CDM Ground Wire Breaking - 75 thru 125

Models Affected

1997 Mariner and Mercury

Figure 1. Terminal Installation

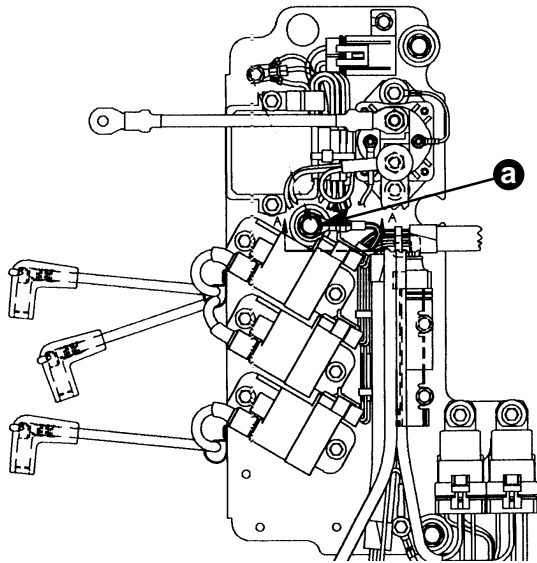
On some of the 3 cylinder 75 HP and 90 HP models listed above, the engine wire harness CDM ground terminal with three black wires may break off resulting in a no spark condition. The failure occurs when the wire ring terminal on the three black ground wires contacts the CDM case and bends the terminal as the rubber mounted electrical plate moves. We have NOT received a documented failure on 100/115/125 models. All 75-125 models after the serial group listed will have the terminal installed on top of the existing large washer, a small stainless steel washer added under the head of the mounting bolt, and the terminal positioned correctly as shown in the following diagrams.

The CDM ground wire terminal must be installed:
between the original large washer 12-56720 (bottom) and new stainless steel small washer 12-36001 washer (top).
with the wire crimp "UP" (away from the mounting plate).
with the wire crimp positioned at 3 o'clock on the 75/90.

- a - New Small Stainless Steel Washer P/N 12-36001
- b - Wire Ring Terminal with Crimp Facing "UP"
- c - Existing Large Washer P/N 12-56720 Under Terminal
